This bulletin deals with issues of immediate and significant relevance to all users of Filter Monitor filtration systems in Aviation Fuel service (both Avgas and Jet), including upstream of airport locations. The purpose of this bulletin is to inform current users of all filter monitor filtration systems of:

This Bulletin is intended to be the first of a series of communications for the implementation of JIG’s strategy on phasing out all filter monitor technology, in line with the position of the IATA SAP Special Interest Group. This bulletin supersedes JIG Bulletins 49 and 72. The circumstances that have caused this reissue require immediate consideration and action by all users of Filter Monitor filtration systems in Aviation Fuel service.

EI 1583 7th edition

Appendix 3 - Comparison of 60 and 100 mesh sizes for strainers

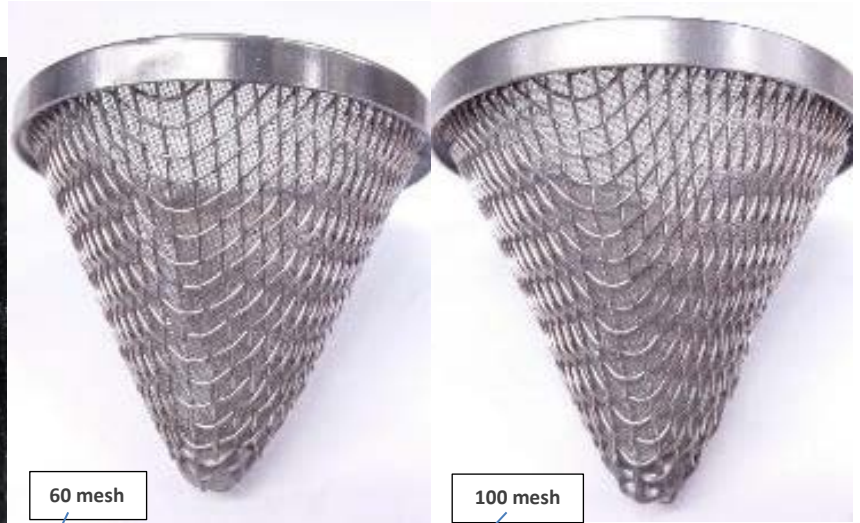
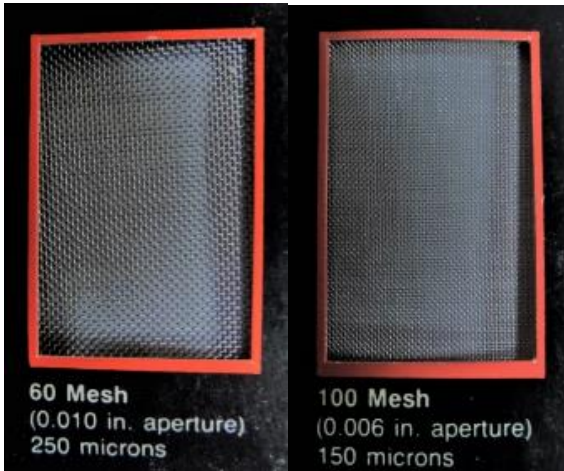
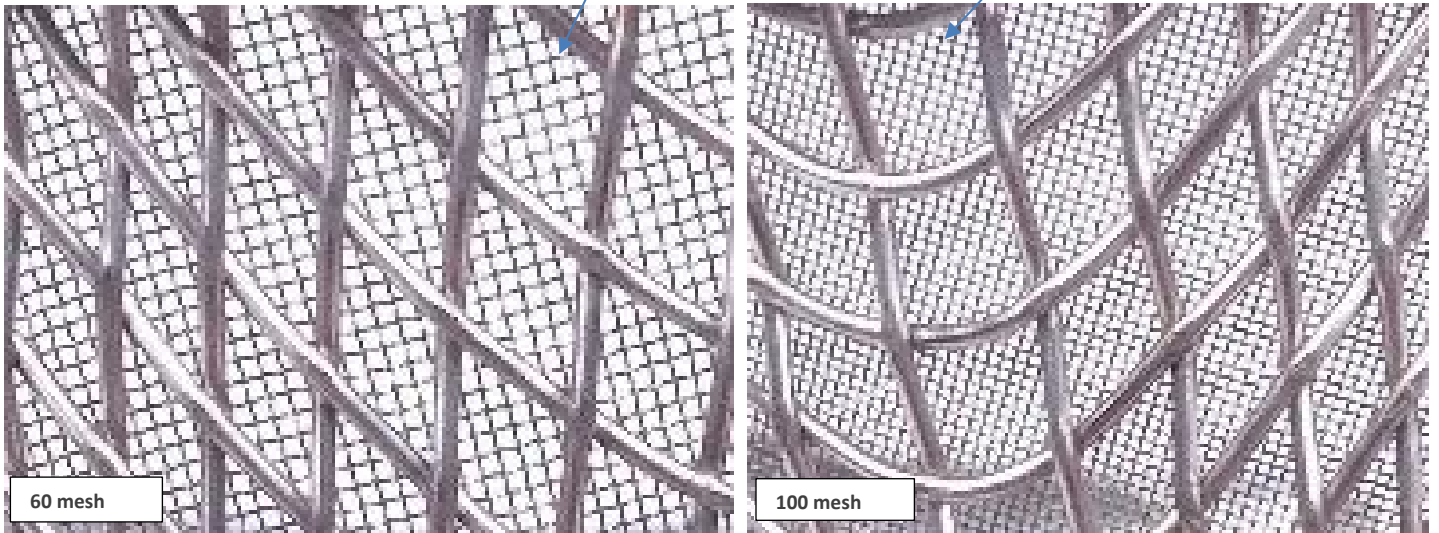
5	Adjust the activation point of DP switches currently fitted on all filter monitor vessels to 15psi (1.0 bar), in accordance with the equipment manufacturers' procedures.	JS	31/1/2018
6	If not already in place, change all hose-end strainers on fuelling equipment fitted with filter monitors to 100 mesh size.	JS	31/1/2018
7	All 2" filter monitor elements in service shall be compliant to EI 1583 7 th edition	JS	30/6/2018
8	All 6" Out to In (direction of flow) filter monitor elements in service, that cannot be converted to an EI 1581 6 th ed. FWS, shall be compliant to EI 1583 7 th edition. Note: If the due date cannot be met due to limited supply options of EI 1583 7 th ed. 6" elements, a revised due date will be considered by JIG in a future JIG Bulletin.	JS	30/6/2018
9	Regardless of their element flow configuration, all converted filter monitor systems (i.e. converted from a previous FWS configuration) with 6" filter monitor elements shall be re-converted to EI 1581 6 th edition FWS, with advice from the filter manufacturer	JS	30/6/2018

(6) See also Appendix 3 in this Bulletin
